PLANNING COMMISSION

STAFF REPORT
Planning Commission Meeting April 25, 2016

PROJECT # / TITLE: Case # 15-13

REQUEST: Final Site Plan-Addition

1 A1 SITE PLAN
1" = 20'
0' 20' 40' 60'

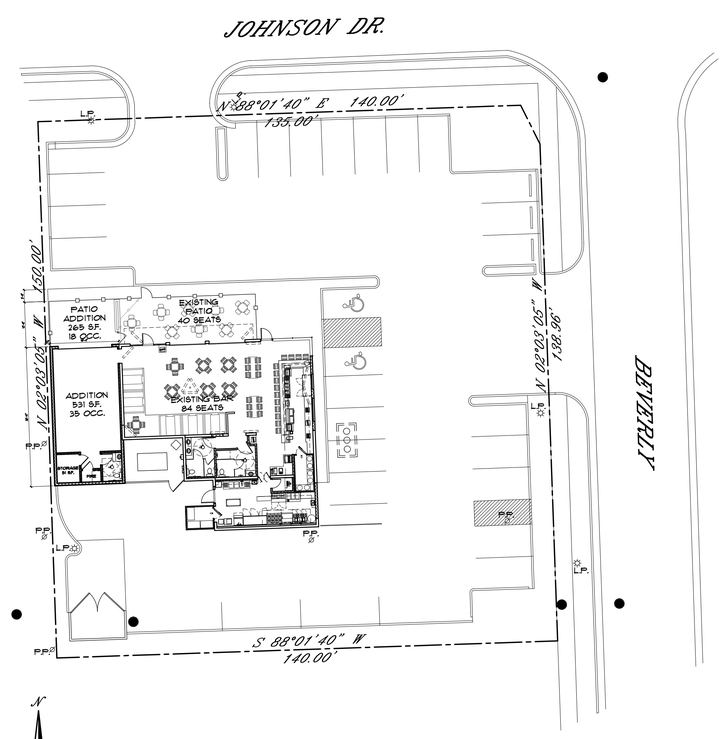
Staff Notes: The applicant is not proposing any changes to the overall design of the parking lot or site access. Sidewalks and parking lot curbs were designed and replaced by the City as part of the Johnson Drive improvement project before the current owner purchased the property. Half of the parking stalls are located between the building and Johnson Drive. Street trees and screening landscaping were installed at staff's request in 2014.

-There is adequate space on the site to allow for circulation of customer traffic and service by trash haulers after the addition is made with no impact to traffic on adjacent public streets.

1 A3 NORTH ELEVATION
1/4" = 1'

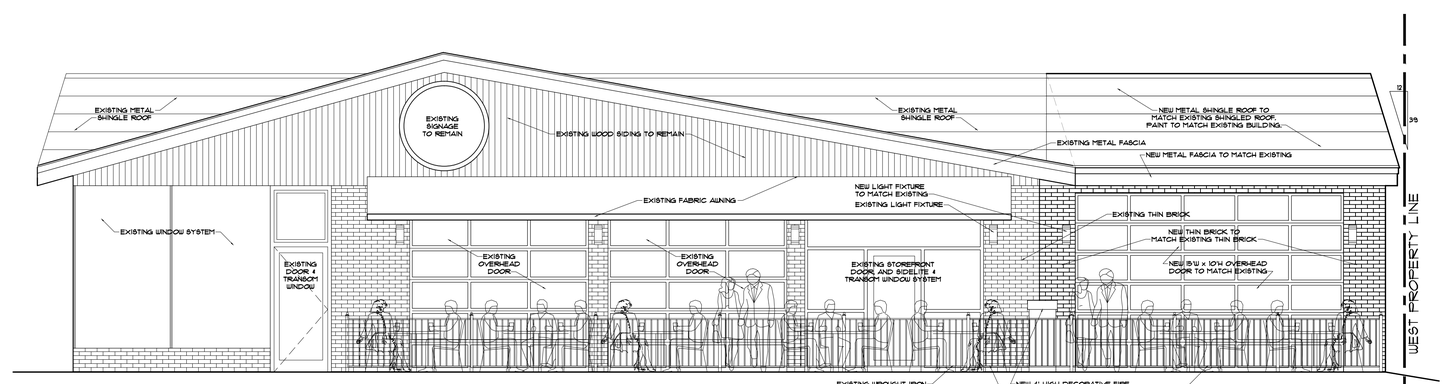
Staff Notes: The north and east facades of the building are the most visible. The addition will primarily be to the north and west facade. The applicant is proposing to continue the use of existing facade elements such as overhead doors on the addition.

Staff Notes: The addition include a roll up overhead door on the north facade.
